Access Compliance Report

Public Rights-of-Way

Intersection ID: 48644	Main Street: SOCATA_WY	Cross Street: ROCKY_FORD_CLUB_RD	Location:	N
ADA ID: A3333496489A	Ramp Type: Perp	Initial Pass/Fail: Pass	Overall Compliance: No	Severity Score: 7.5

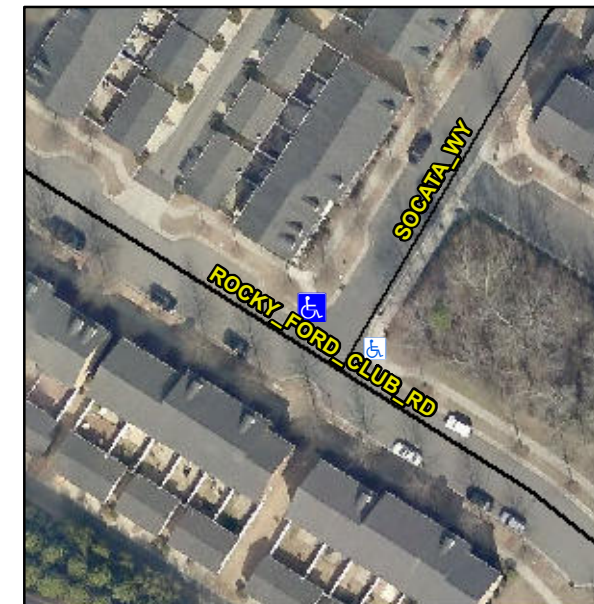
**Remove & Replace Entire Ramp.
Remove & Replace Gutter.**

**R304.2.2-Perp, R304.3.2-Para,
R304.5.3, R305.1.4, R302.7, R304.5.4**
